ITEM: 6.1	COMMITTEE OF ADJUSTMENT REPORT SUMMARY MINOR VARIANCE APPLICATION FILE NUMBER A009/23 89 ISERNIA CRESCENT, WOODBRIDGE
------------------	--

**COMMITTEE OF ADJUSTMENT REPORT
MINOR VARIANCE APPLICATION
A009/23
89 ISERNIA CR, WOODBRIDGE**

ITEM NUMBER: 6.1	CITY WARD #: 3
APPLICANT:	Angela Oppedisano & Nicolino Oppedisano
AGENT:	Lucas Cocomello
PROPERTY:	89 Isernia Crescent, Woodbridge
ZONING DESIGNATION:	See below.
VAUGHAN OFFICIAL PLAN (2010) DESIGNATION:	Vaughan Official Plan 2010 ('VOP 2010'): "Low-Rise Residential"
RELATED DEVELOPMENT APPLICATIONS:	None
PURPOSE OF APPLICATION:	Relief from the Zoning By-law has been requested to permit a proposed cabana, two existing sheds and reduced rear yard landscaping requirements.

SITE PLAN

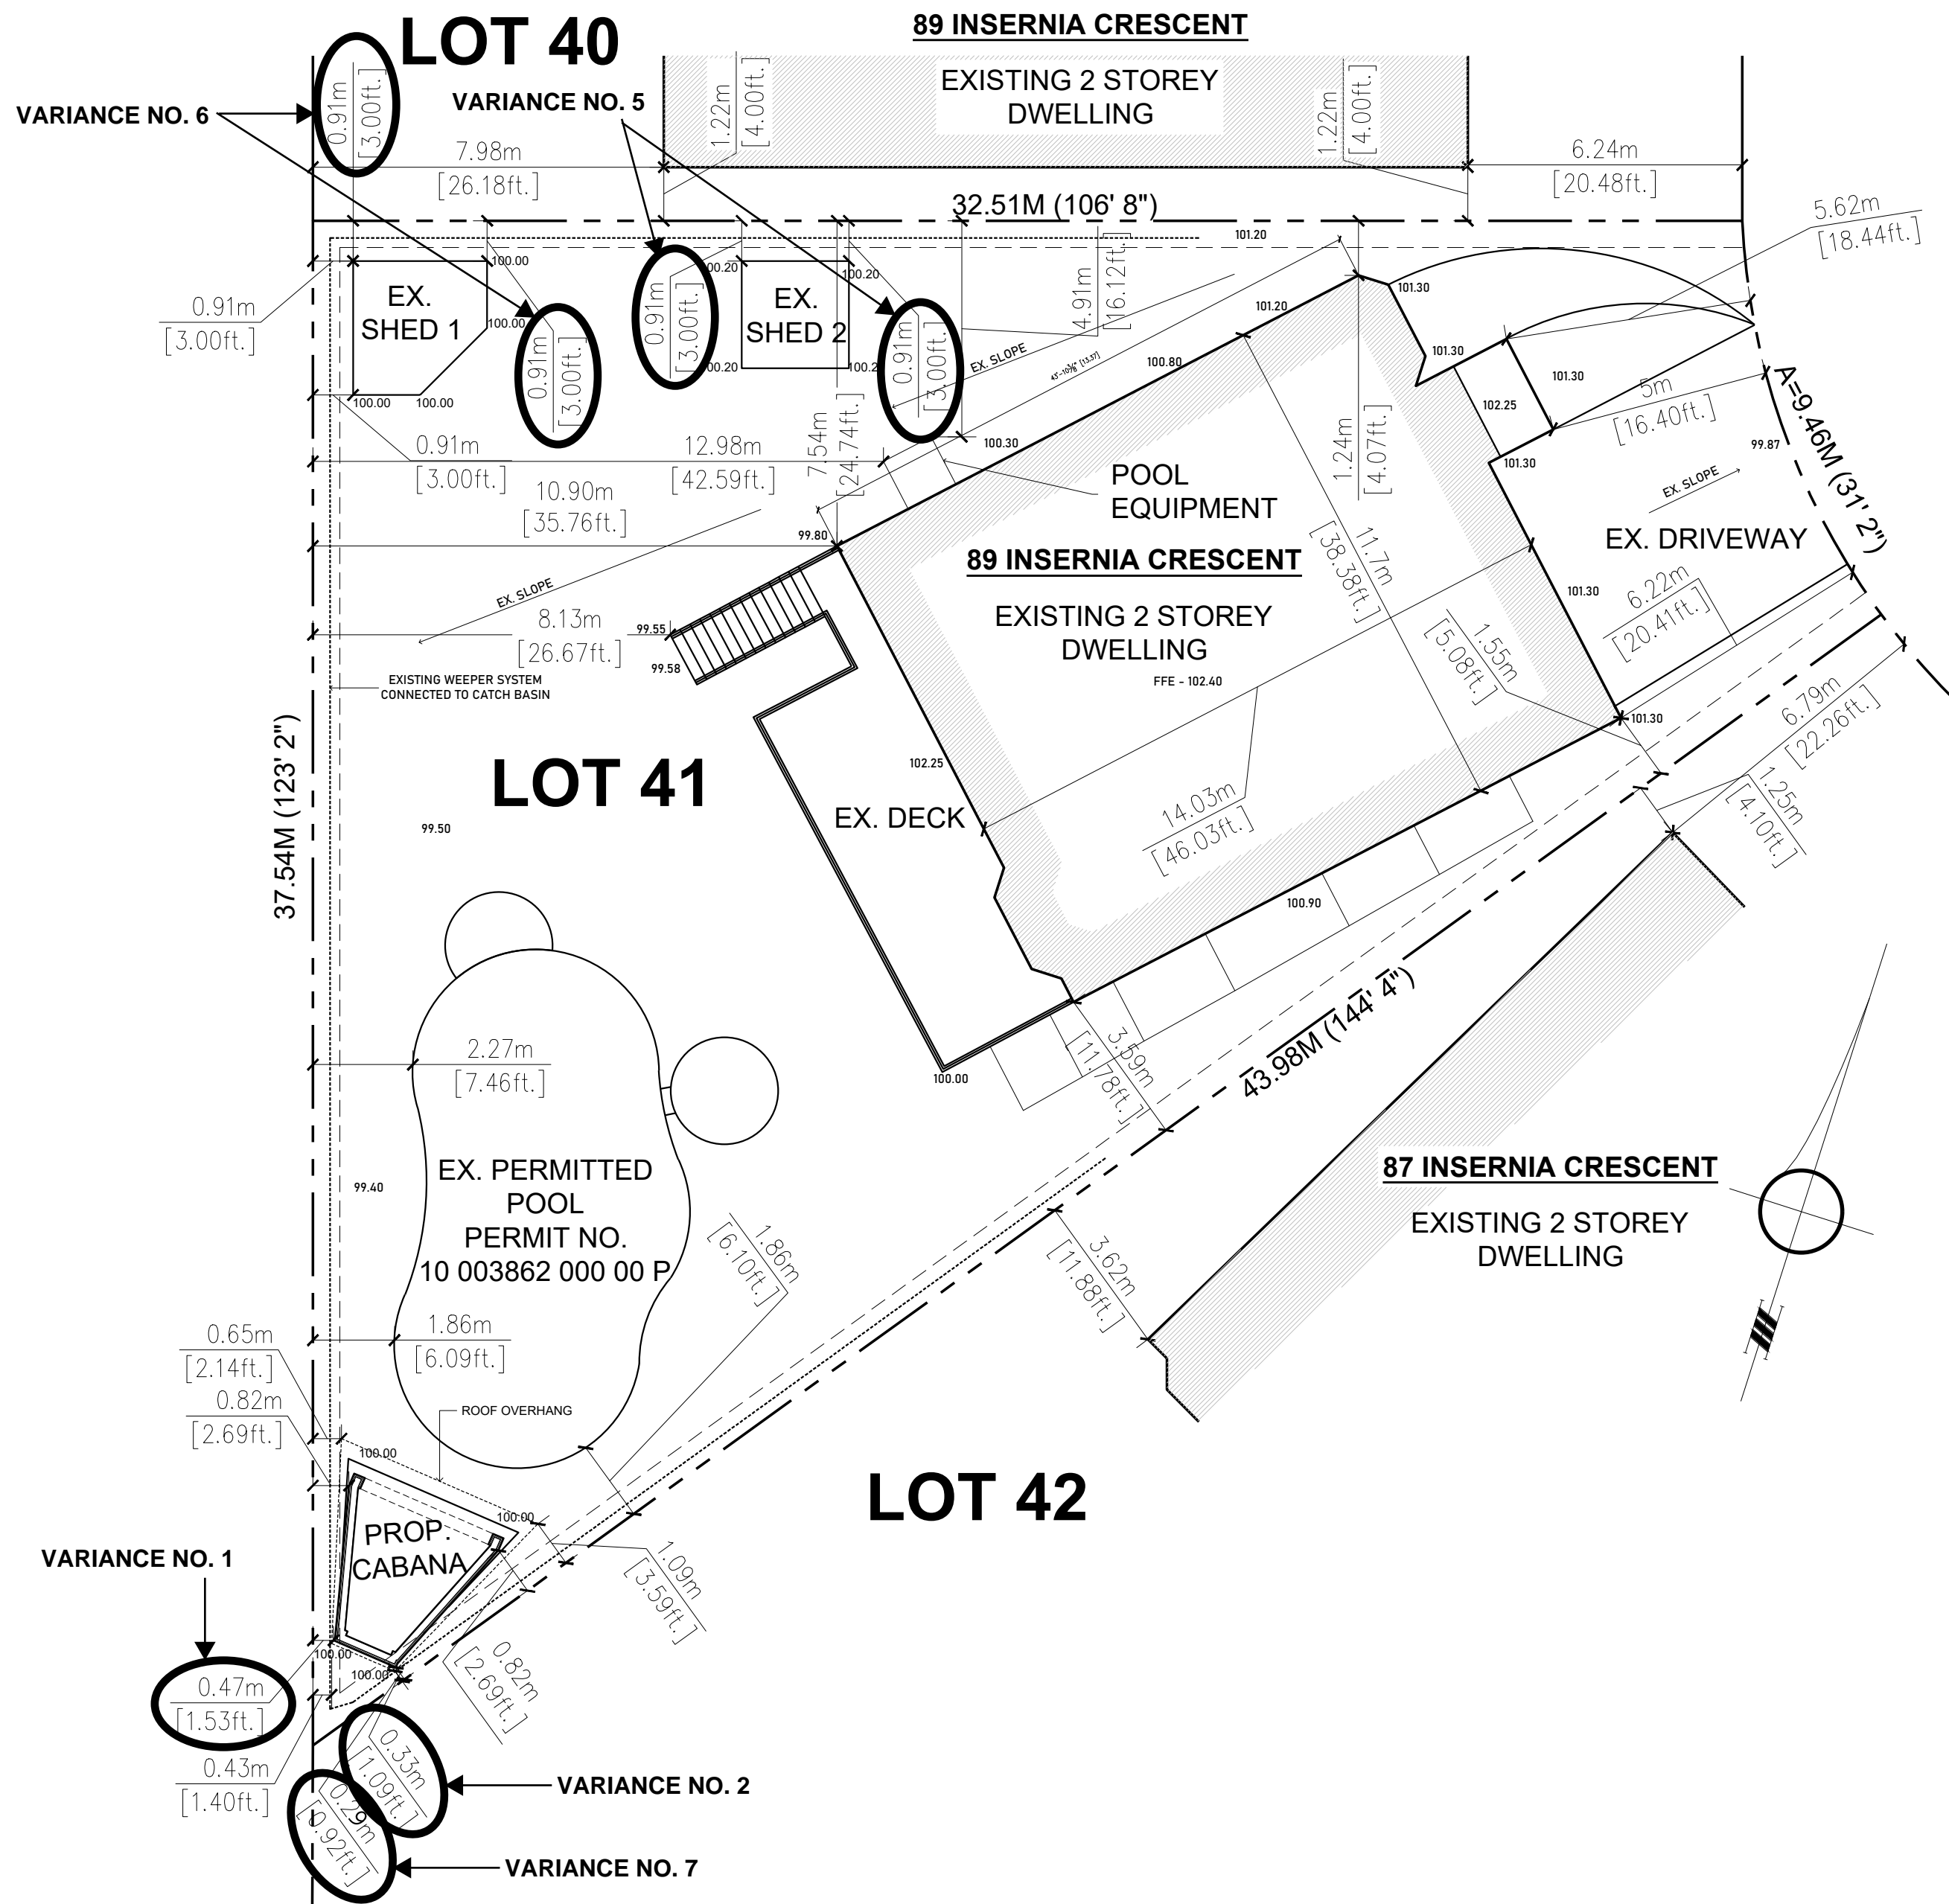
The Applicant has identified an existing weeping tile system that runs adjacent to the rear yard property line, behind the proposed cabana. The implementation of this system will mitigate any potential storm water impacts to the existing rear yard swale.

The Development Planning Department has no objection to Variances 1 and 2 to permit a residential accessory structure (cabana) with a height greater than 2.8 metres to be located a minimum of 0.47 metres from the rear line and to be located a minimum of

The Development Planning Department has no objection to Variances 7 and 8 to permit a minimum distance of 0.29 metres from the eaves and gutters of the residential accessory structure (cabana) to the rear lot line and to permit a minimum distance of 0.15 metres from the eaves and gutters of the cabana to the interior side lot line. The proposed encroachment does not propose any adverse impacts to abutting properties as the eaves and gutters do not overhang over the property line and sufficient space for maintenance is provided.

The Development Engineering Department does not object to the Minor Variance application A009/22.

FRONT & REAR ELEVATION

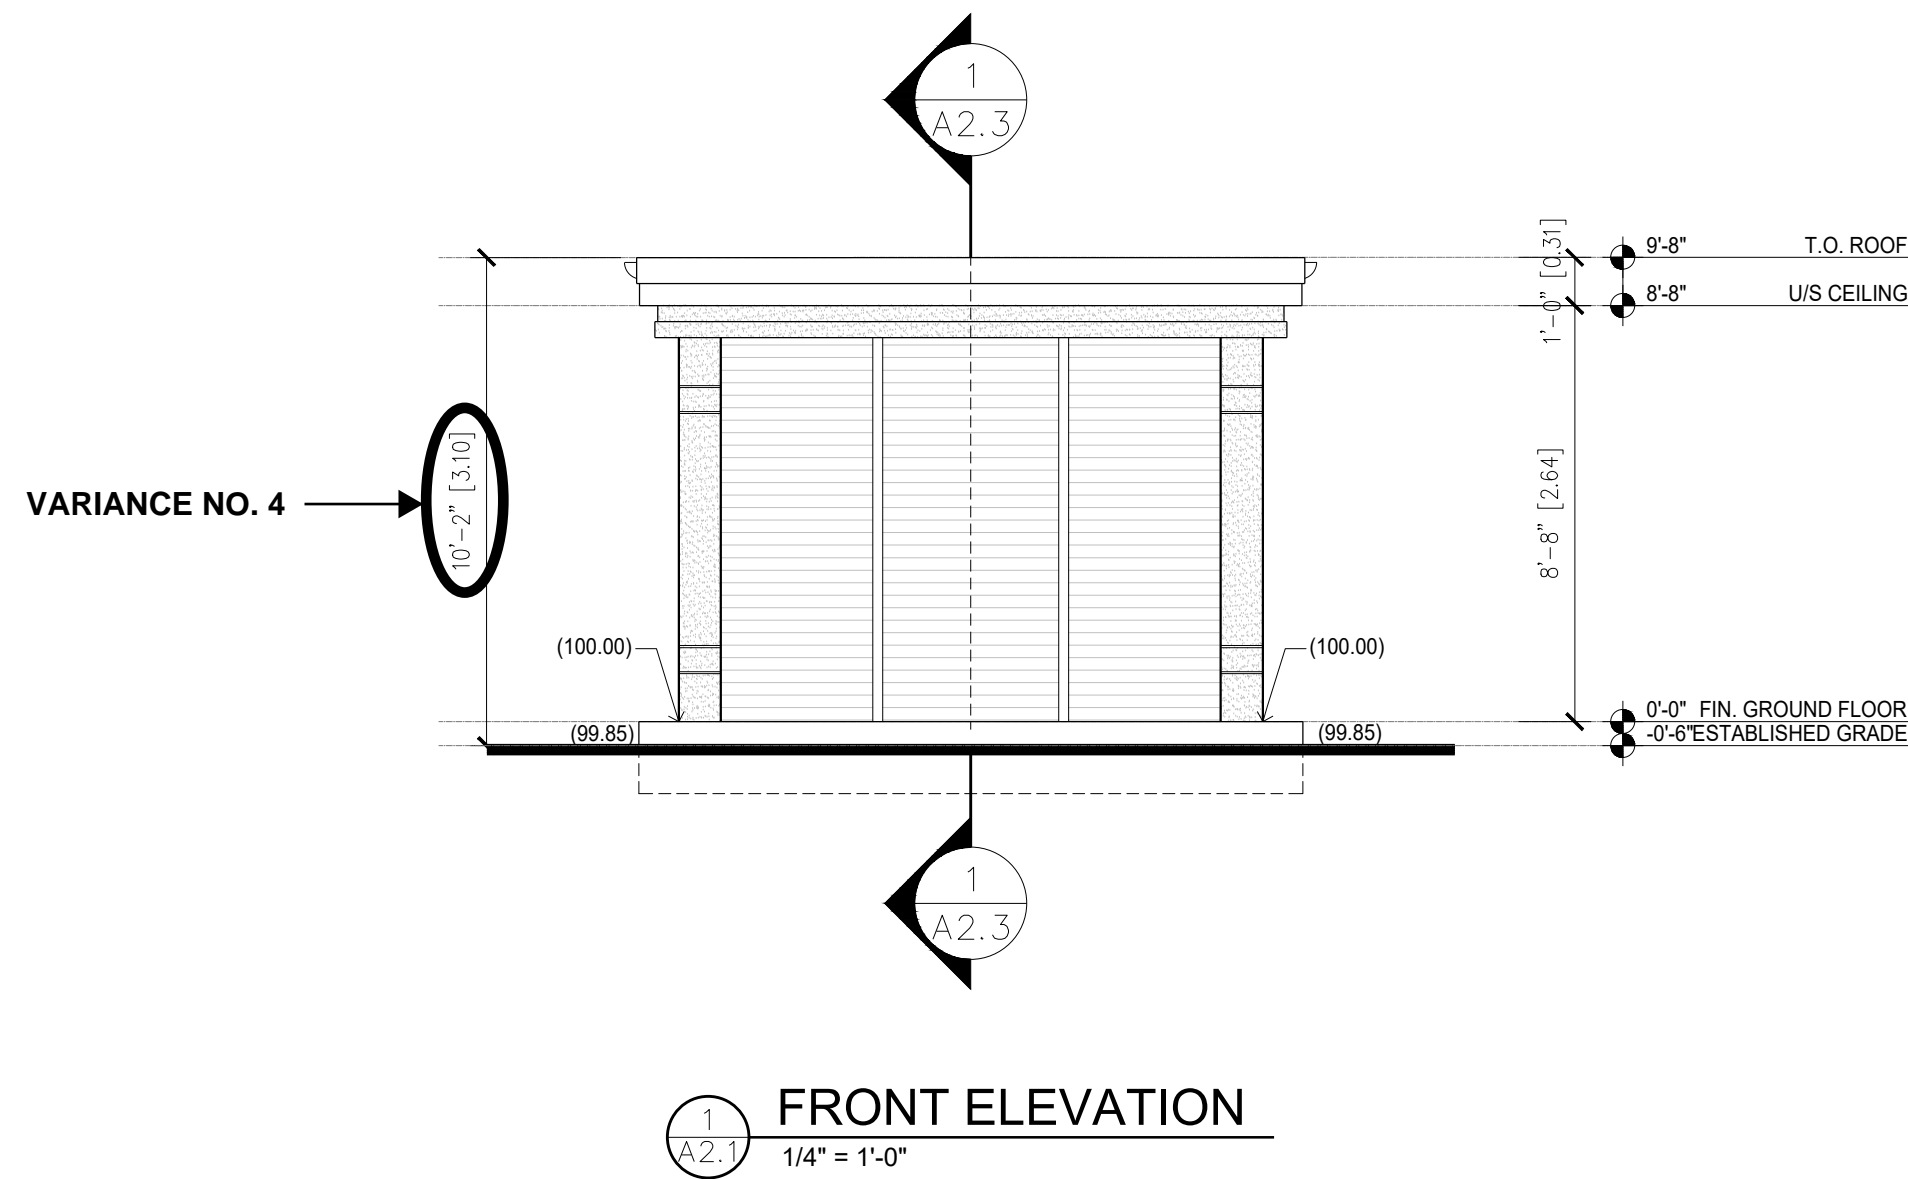
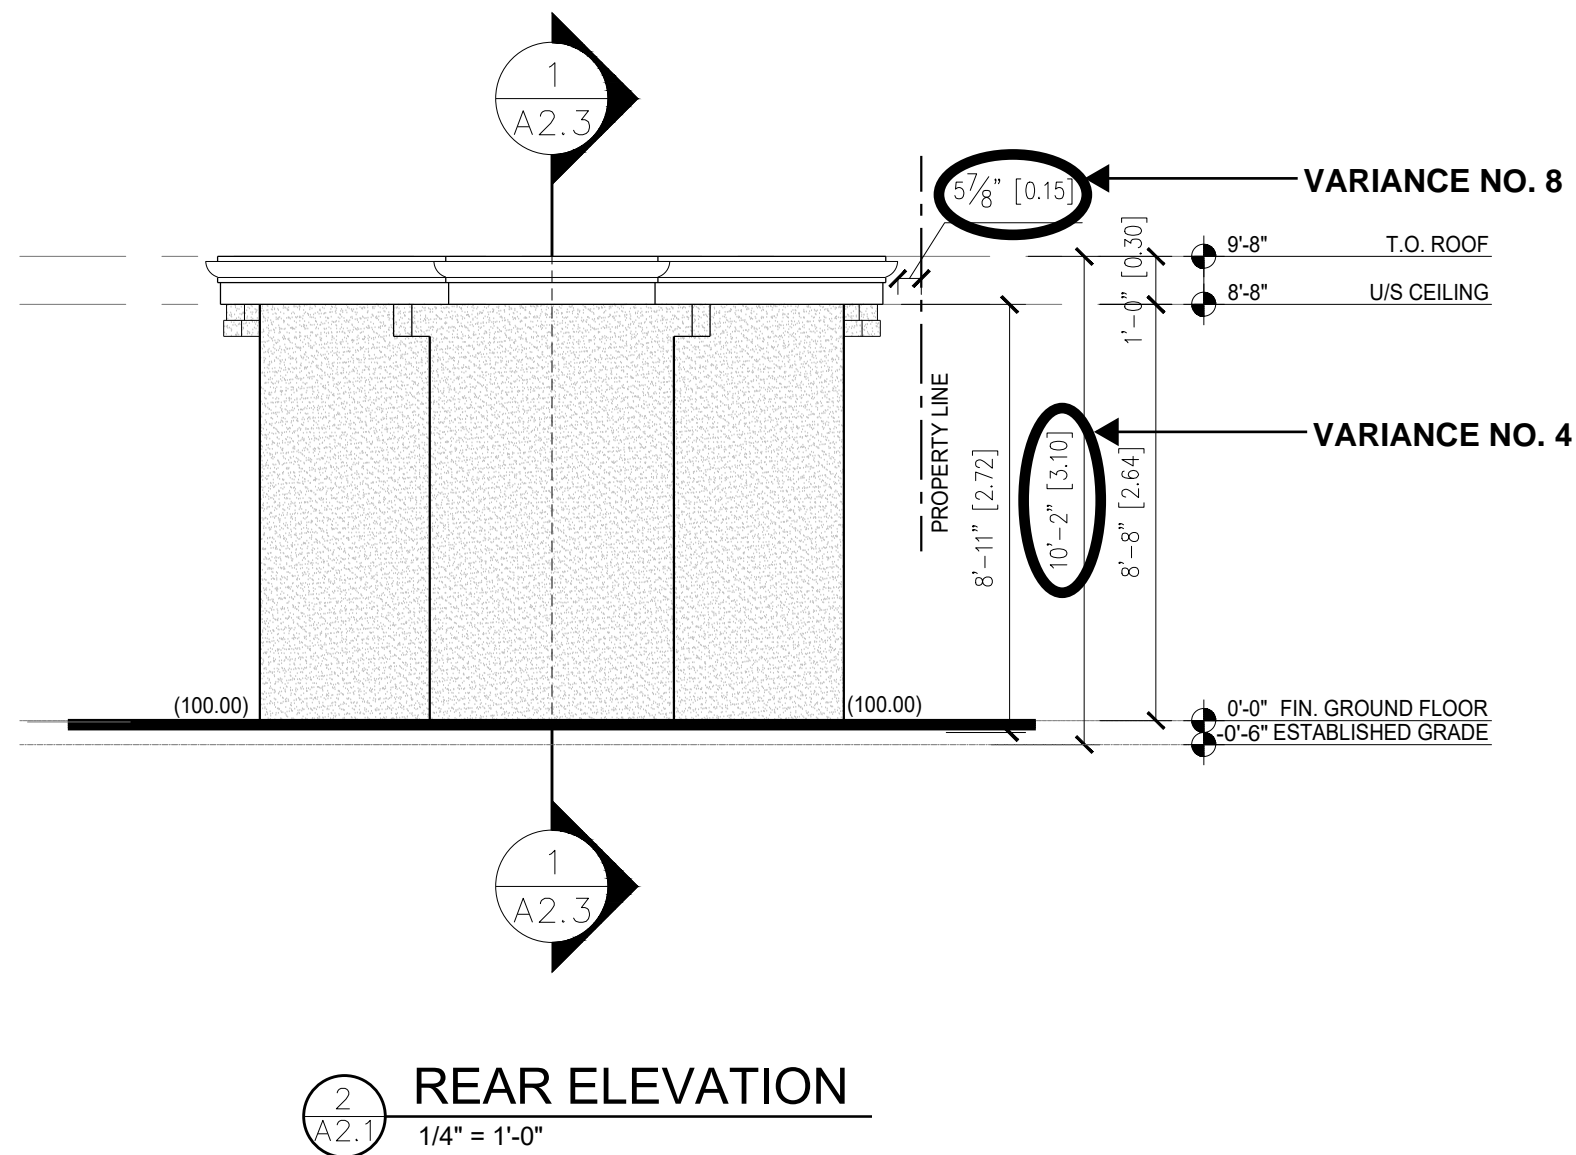
The Development Planning Department has no objections with Variance 4 to permit a maximum cabana height of 3.10 metres, which is 0.1 m in excess of the required maximum height in the Zoning By-law. The cabana has a flat roof design with the requested relief measured between the established grade to the top of the roof. The proposed increase in height is negligible from a visual perspective and is considered to be minor in nature. As such, the 0.1 m increase in height in combination with the reduced interior side yard setbacks (Variances 1 & 2) for the Cabana are not anticipated to pose adverse use, massing, or privacy impacts to the neighbouring properties.

SITE PLAN

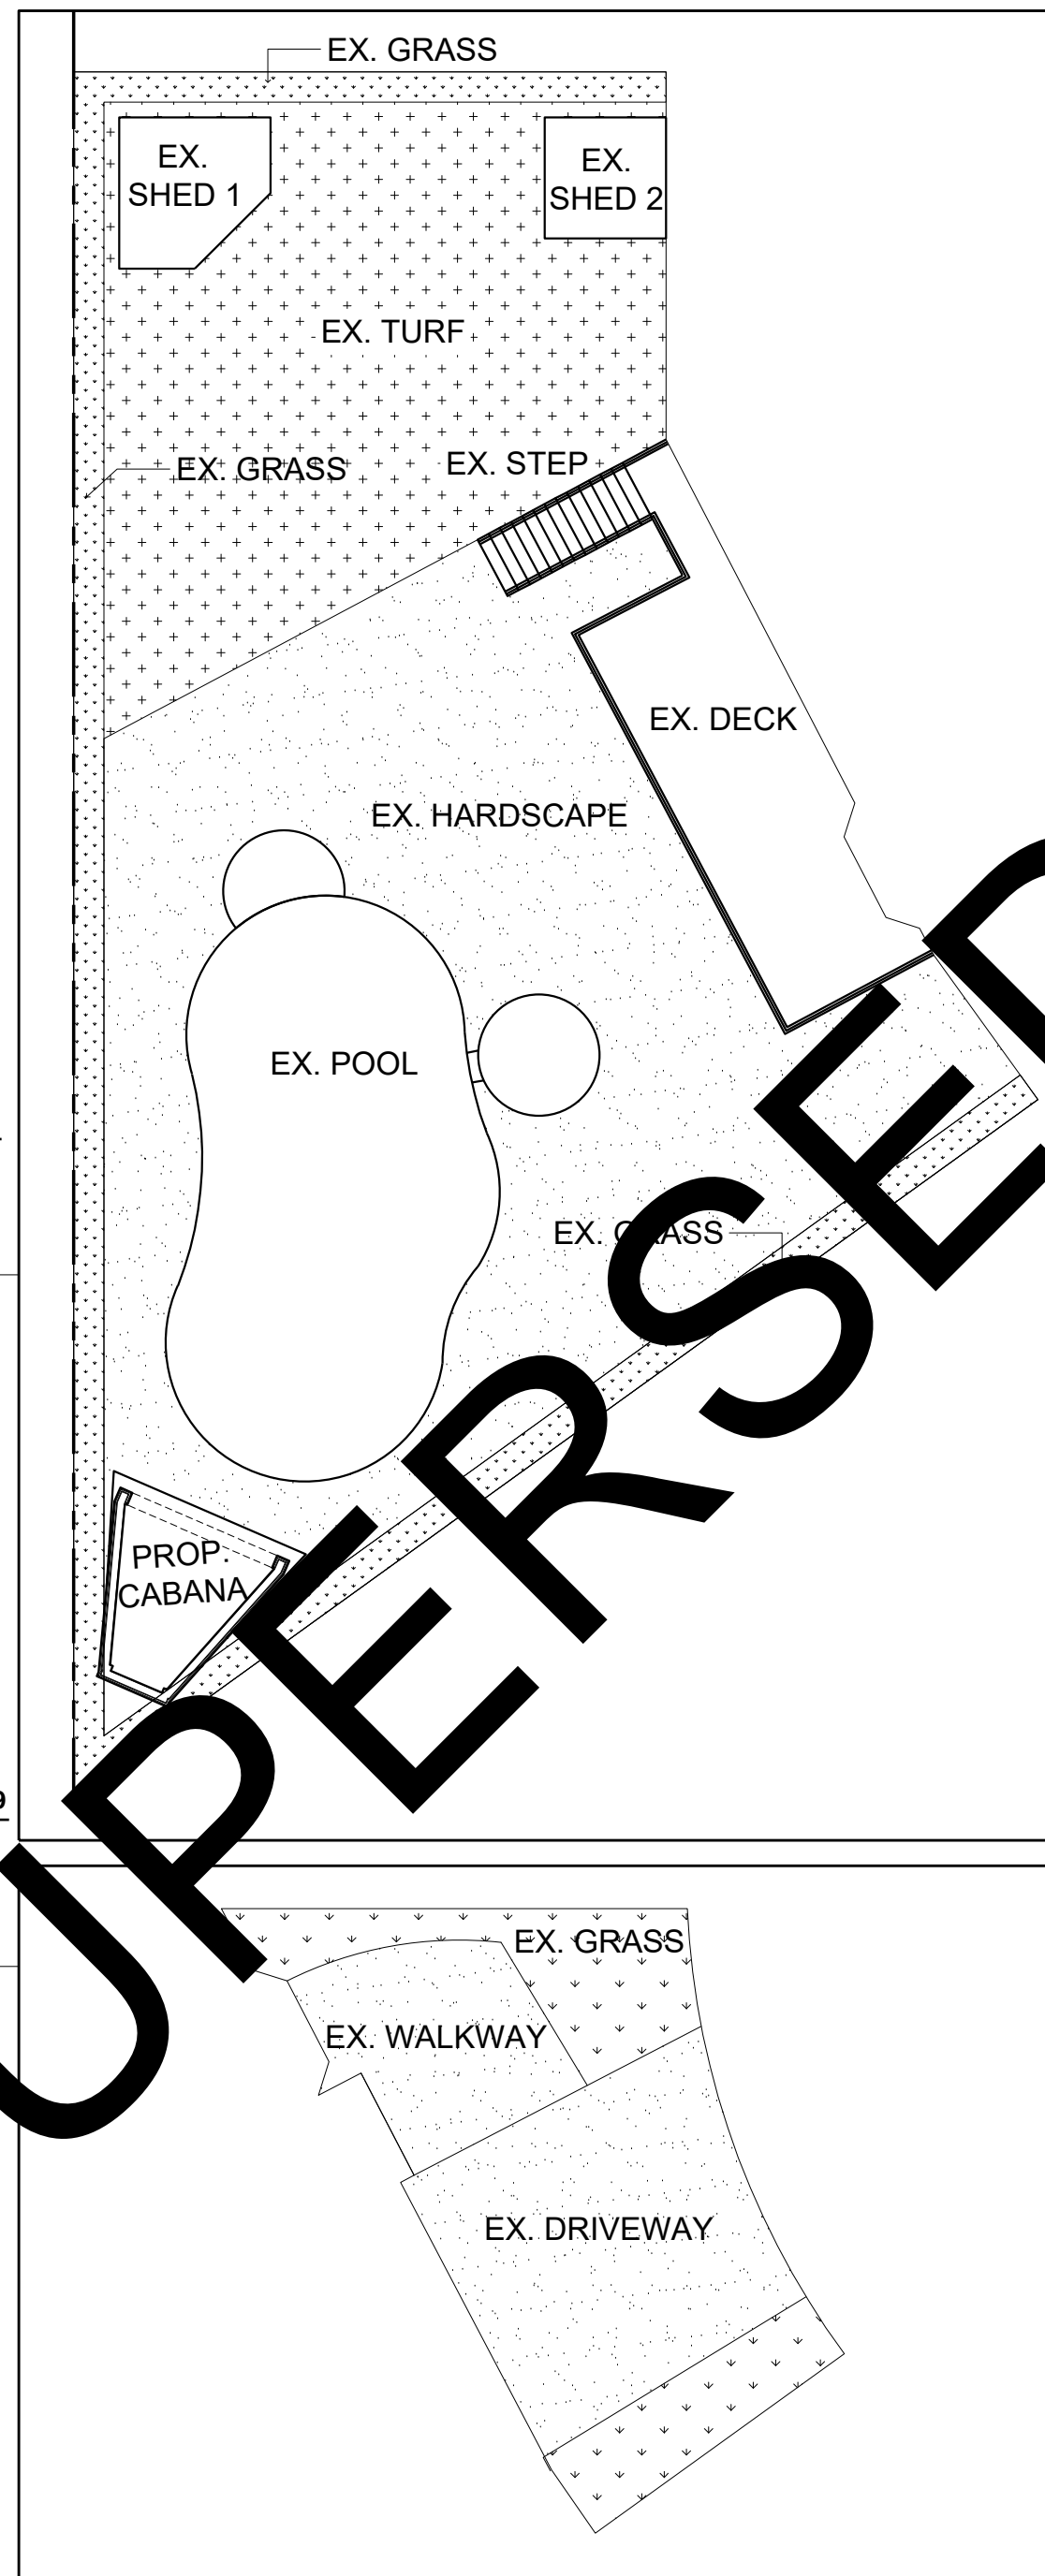
Variance 3 is to permit a minimum rear yard soft landscape of 48.72% (142.67 m²) for the portion of the yard exceeding 135 m² and Development Planning Staff have no objection to the proposed reduction in rear yard soft landscaping. The Owners have revised their application to provide additional rear yard soft landscaping upon recommendations from the Development Planning Department. The proposed reduction in soft landscaping is minor in nature and will maintain an appropriate permeable area to facilitate drainage, reduce urban heat island effects, and facilitate the establishment of vegetation. The Development Engineering Department has also reviewed the proposal and is satisfied that drainage in the rear yard will be maintained.
